Meeting Agenda Historic Review Board

Tuesday, September 27, 2016 6:00 PM Commission Chambers

PC 16-095 HR 16-03 Approval of a new detached garage in the McLoughlin

PC 16-096 HR 16-04 Rear and front addition of a locally designated house in the

REVISED: 2/16/16 SHEET: 2 of 3

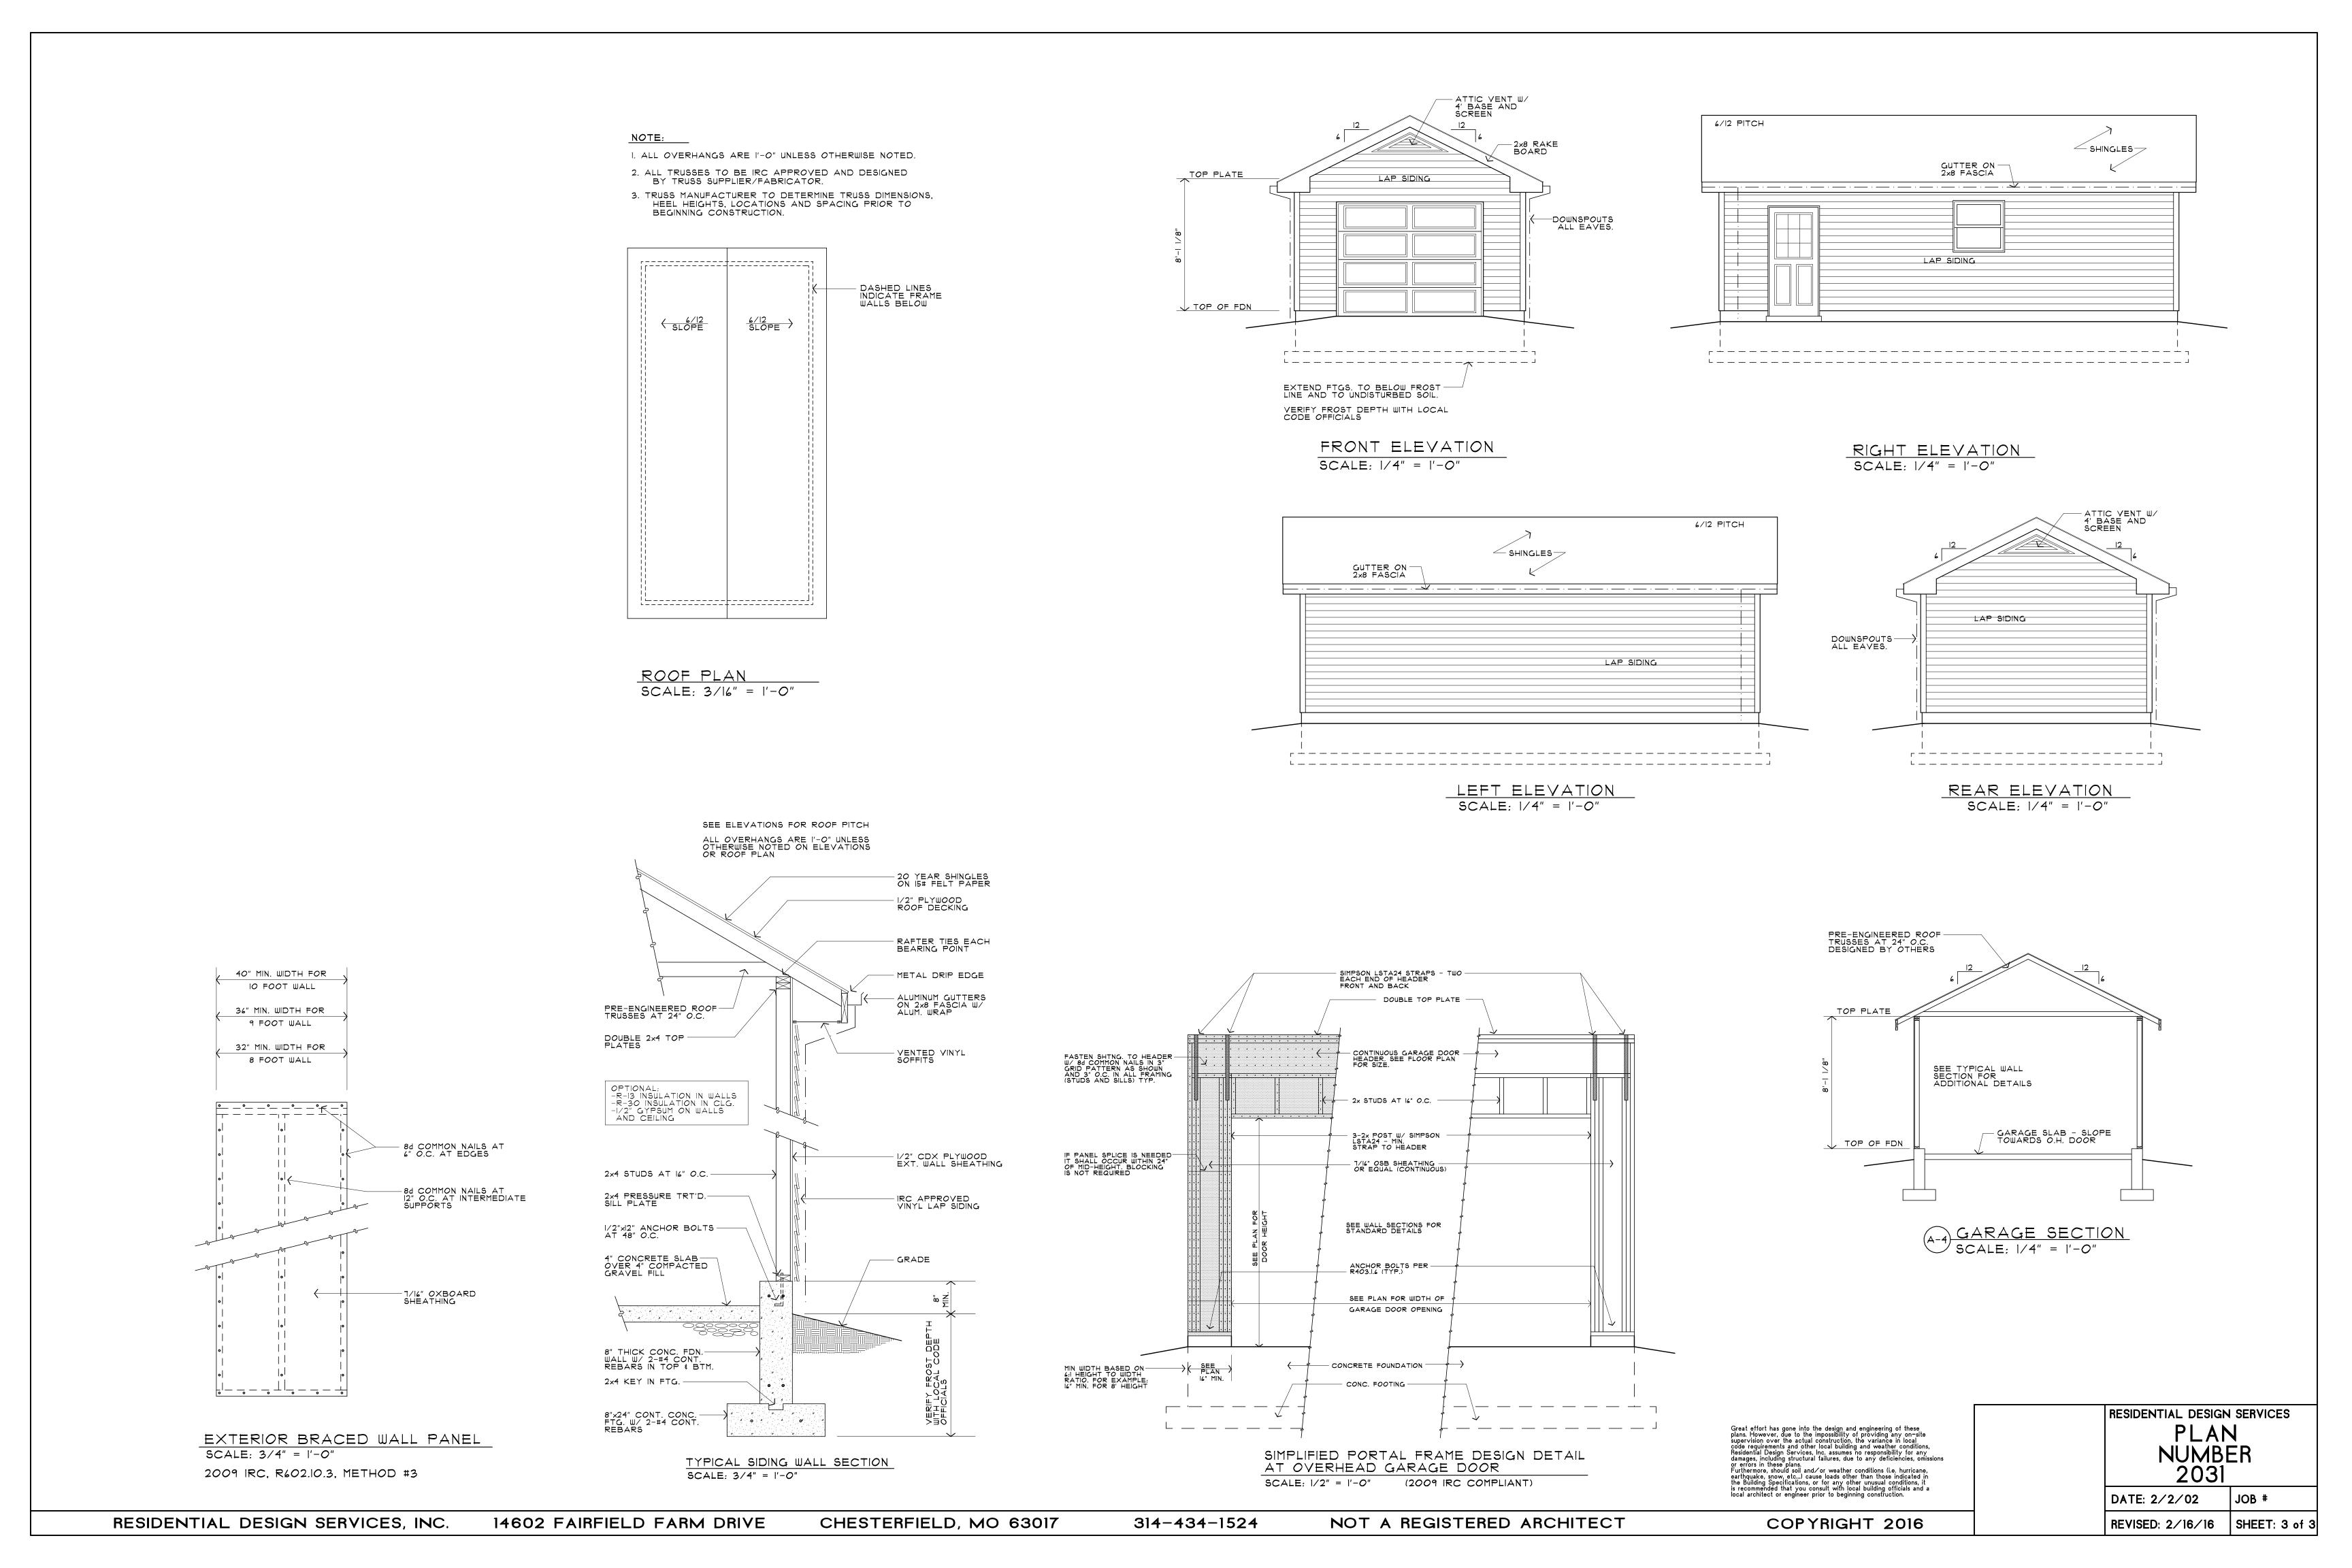
The plan shows that the siding is proposed as vinyl with vinyl soffits. This does not meet the criteria. The garage should also not have returns that have the appearance of a bungalow. The eves should be open. Suggestion- lap siding with a 4" profile.

It appears from the site plan that the garage is only setback 12 feet from 13th Street. Nothing in the narrative addresses the need for a smaller setback. However, the notice mentions requesting a preservation incentive. A setback of between 15 to 20 feet is required under the R-6 zoning district.

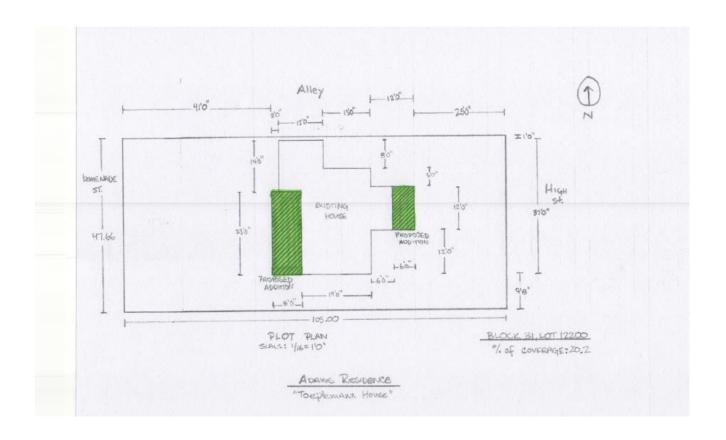
Response: Staff finds that 6 foot front adversely affects the historic significance of the house. The addition visually competes with the prominence of the original historic structure. The rear addition, however, is designed to be compatible, subordinate and clearly differentiates new from old.

Alternately, if the Board determines that the addition can be found to be compatible with the historic house, staff recommends that the HRB provide specific findings for the approval in any motion approving the project to ensure that this decision remains site and project specific and does not create a blanket precedent for future projects.

4. DRAWINGS

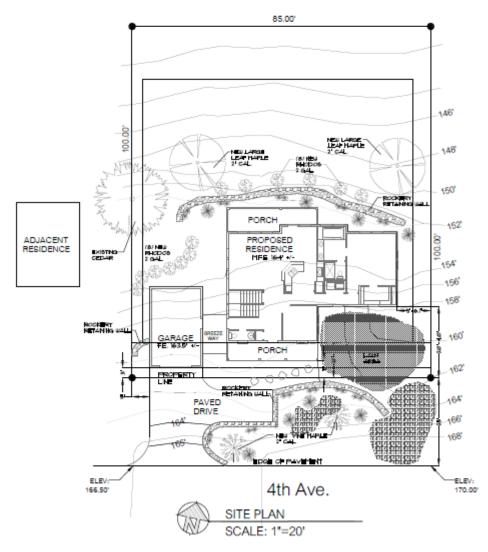
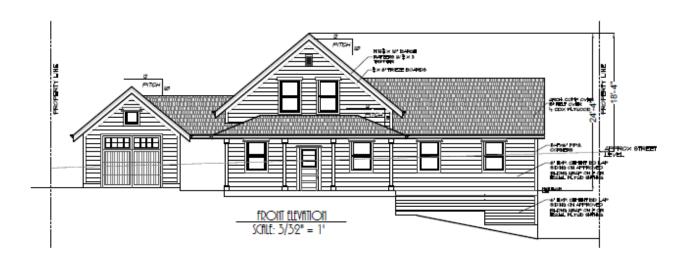
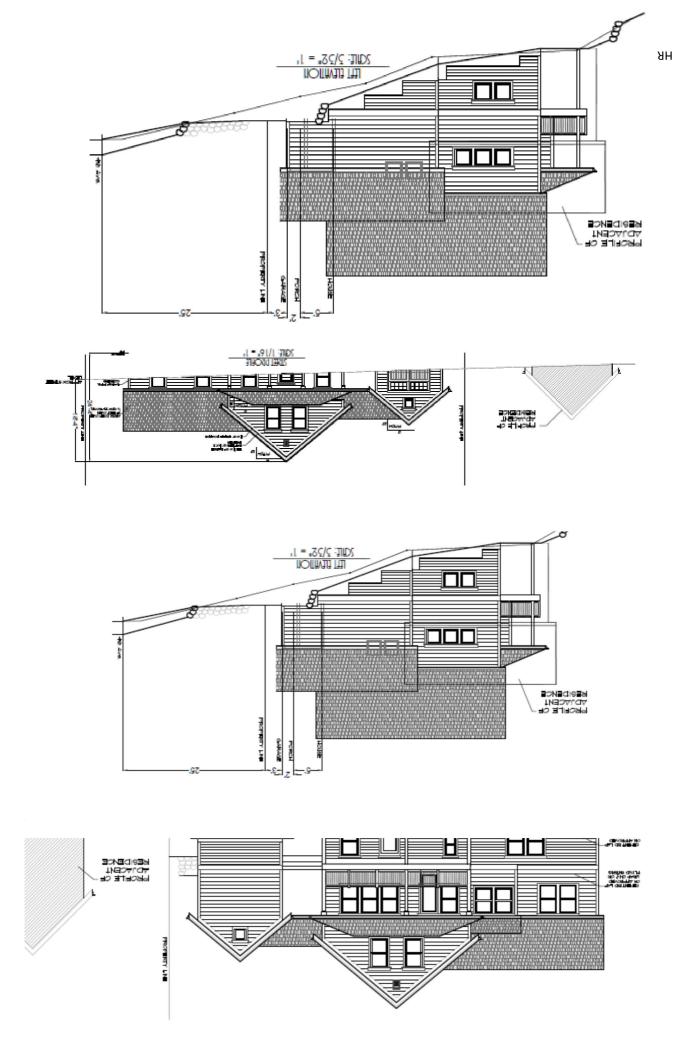
In order to meet the spacing guidelines identified above, staff recommends that the applicant supplement the proposed landscaping plan with additional mitigation/screening trees. Specifically, prior to obtaining a Certificate of Occupancy, the applicant shall submit an amended landscape plan that includes the following:

- 5 additional bushes with a mature height of 4-6 feet and two additional trees with a mature height of 30 feet or more planted within 30 feet of the west property line to better block the garage from the Draper House
- 5 additional bushes with a mature height of a minimum 4-6 feet along the east elevation to break up the massing of the day light basement

- 8. Prior to obtaining a Certificate of Occupancy, the applicant shall submit an amended landscape plan that includes the following
 - a. 5 additional bushes with a mature height of 4-6 feet and two additional trees with a mature height of 30 feet or more planted within 20 feet of the west property to better block the garage from the Draper House
 - b. 5 additional bushes with a mature height of a minimum 4-6 feet along the east elevation to break up the massing of the day light basement.
